Customer: Arrow Lumber-Orting
Job Name: New Lot 32
Job Number: J1114706
Plan: L2-2600-3L

Drawing Type: Roof Trusses
Loading
TC/LL = 25.0 lb
TC/DL = 8.0 lb
BC/DL = 7.0 lb
WIND = 110 mph 'B'

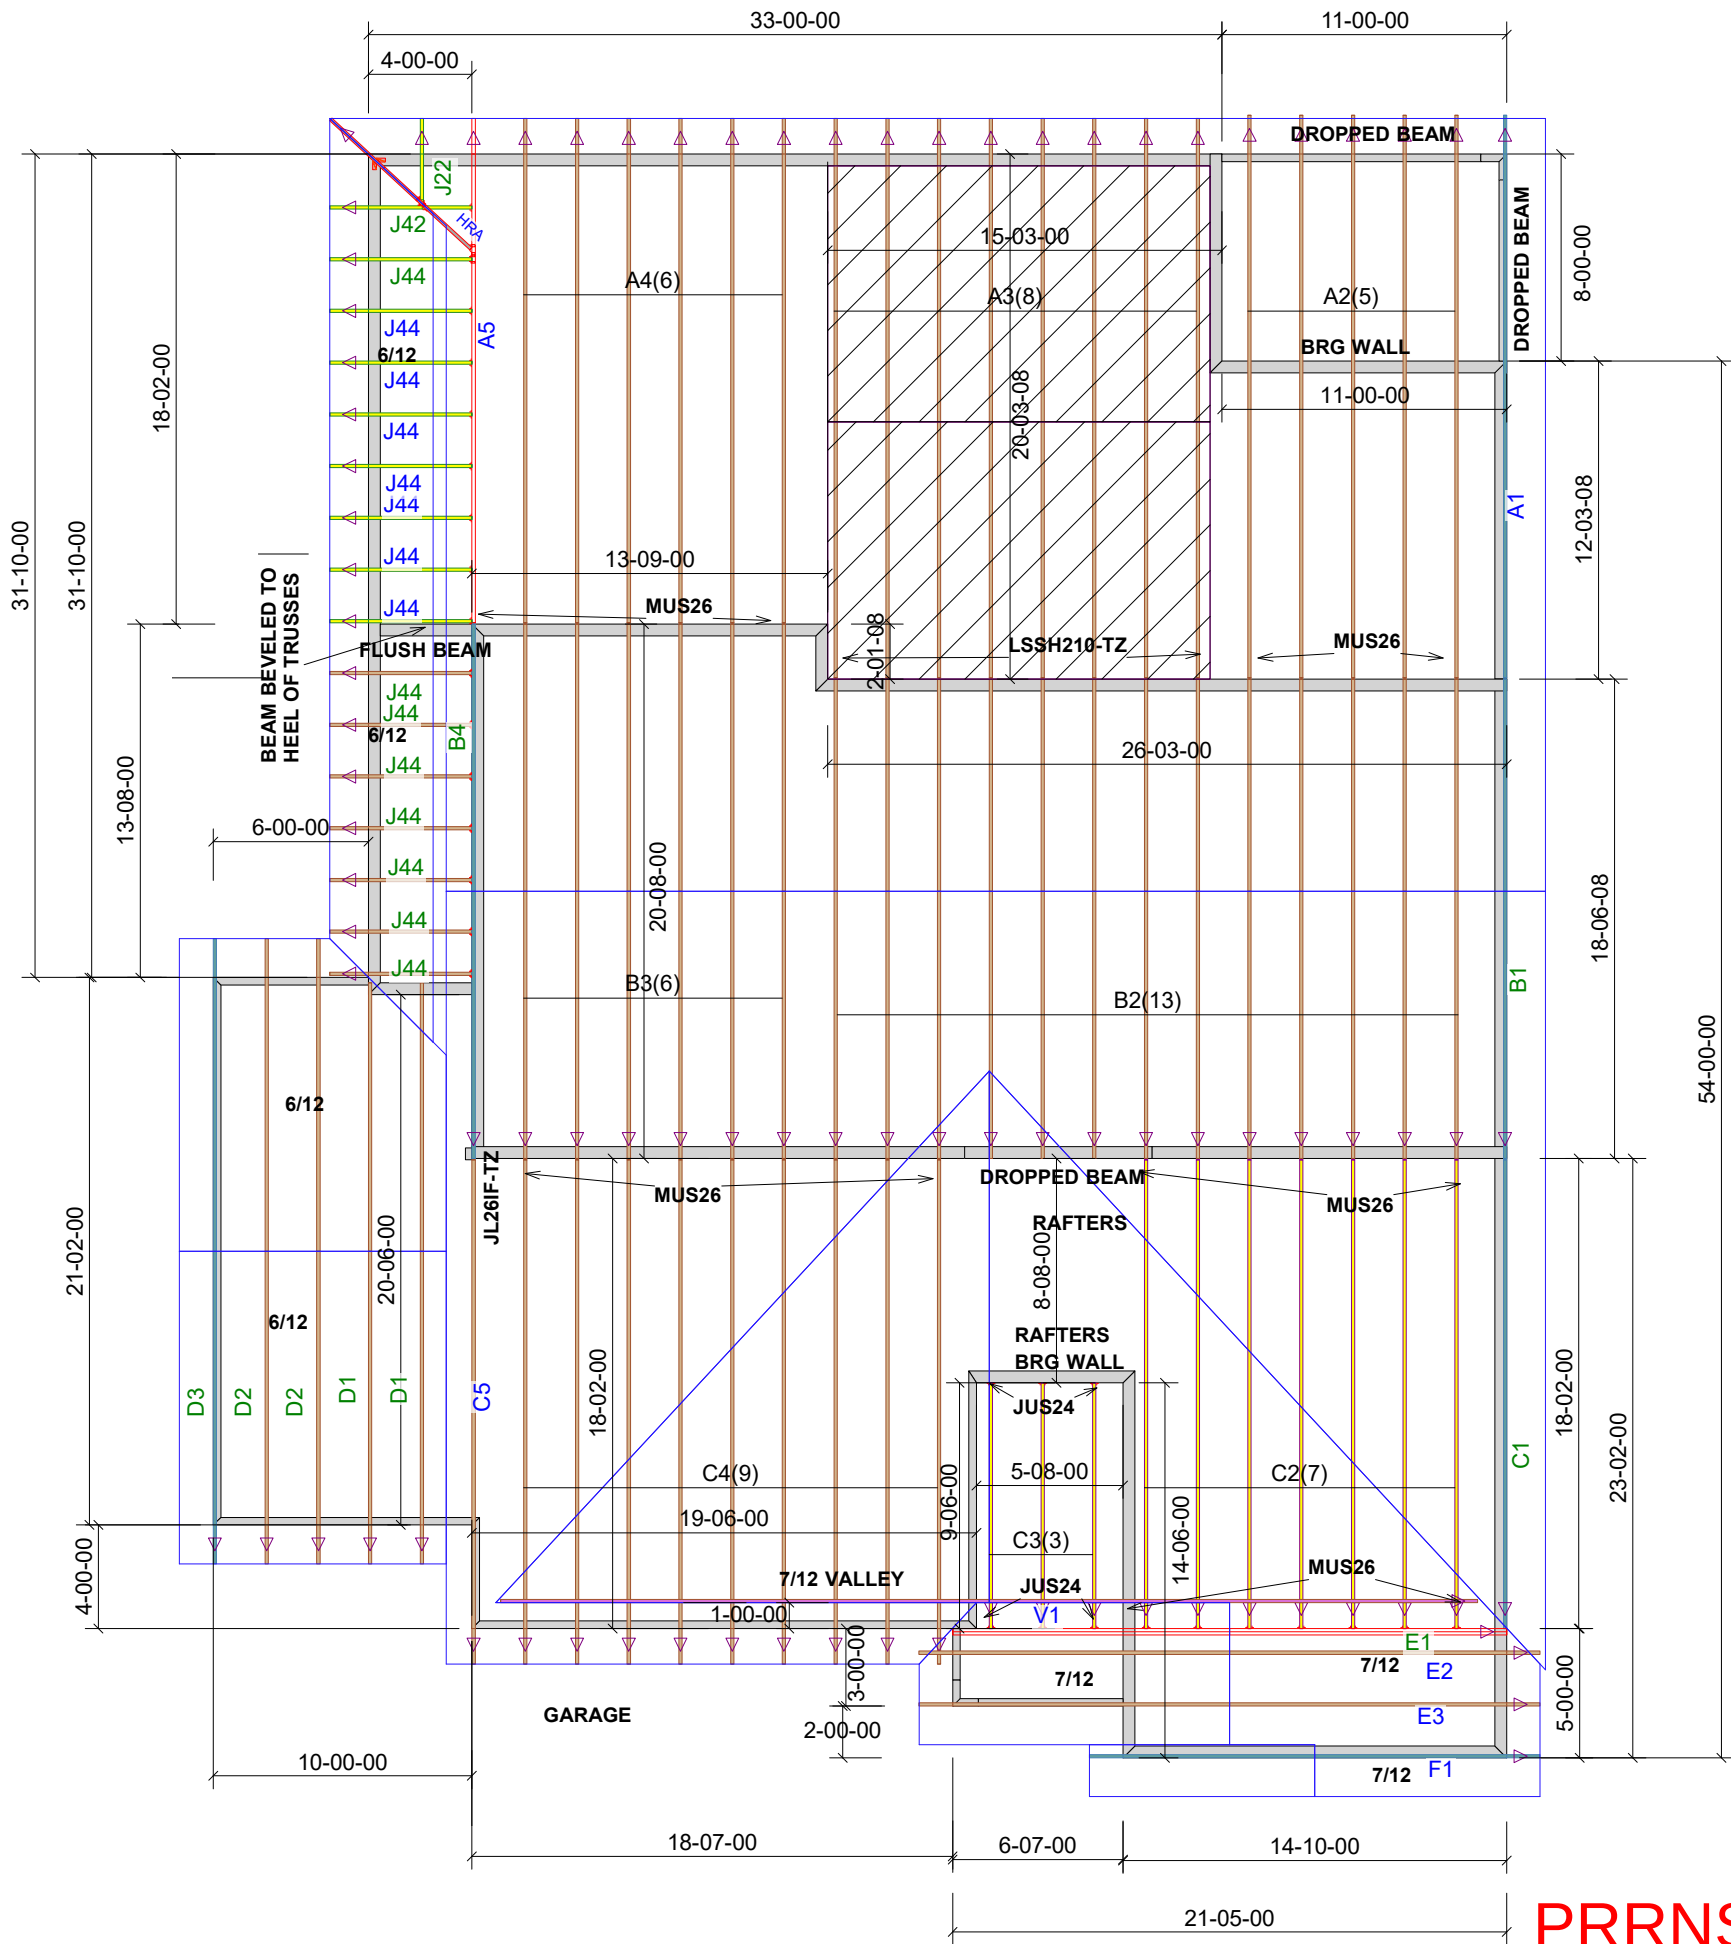
APPROVED TO PROCEED
SUBJECT TO CITY INSPECTORS 12/13/2022 DL

PLEASE VERIFY THE FOLLOWING

- 1. DIMENSIONS
- 2. WALL HEIGHTS
- 3. VAULT
- 4. BEAM BEVELED TO HEELS
